DIVING SYSTEMS INTERNATIONAL, Inc.
425 Garden Street
Santa Barbara, California 93101
Telephone (805) 965-8538, Fax (805) 966-5761

CAUTION Bulletin No. 3 of '95 7 DECEMBER, 1995

**Subject: Drawstring Neck Dam
Alteration For Fit
Products Affected: Kirby Morgan
SuperLite-17A/B & U.S. Navy MK-21
Mod. O & Mod. I Helmets**

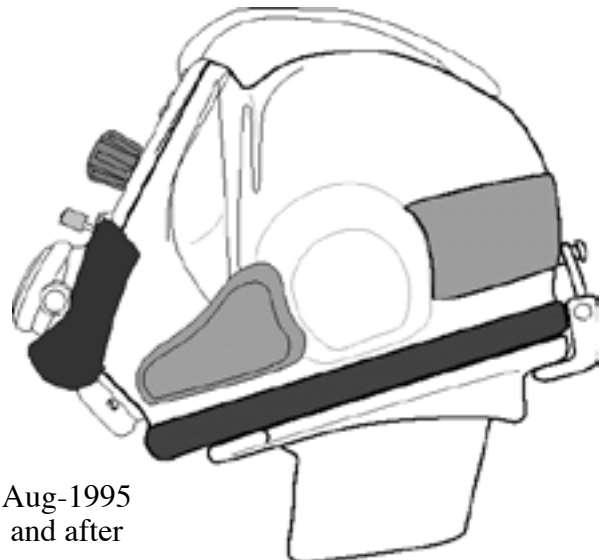
The Drawstring Neck Dam, Part Number 510-533 is the standard neck dam configuration on all SuperLite-17A/B & U.S. Navy MK-21 Mod. O & Mod. I Helmets prior to August, 1995. The 1996 Model SuperLite-17A/B Drawstring Neck Dam has had a design change made to it.

The neck chute of the dam is now angled, allowing the helmet to rest in a more comfortable position and lessening front end ride up. It also fits a wider variety of neck sizes.

Pre Aug-1995

Aug-1995
and after

There are no part number or price changes due to this alteration.

As of 8/15/95, this changed part is shipped as "standard" on all SuperLite-17A/B helmets.
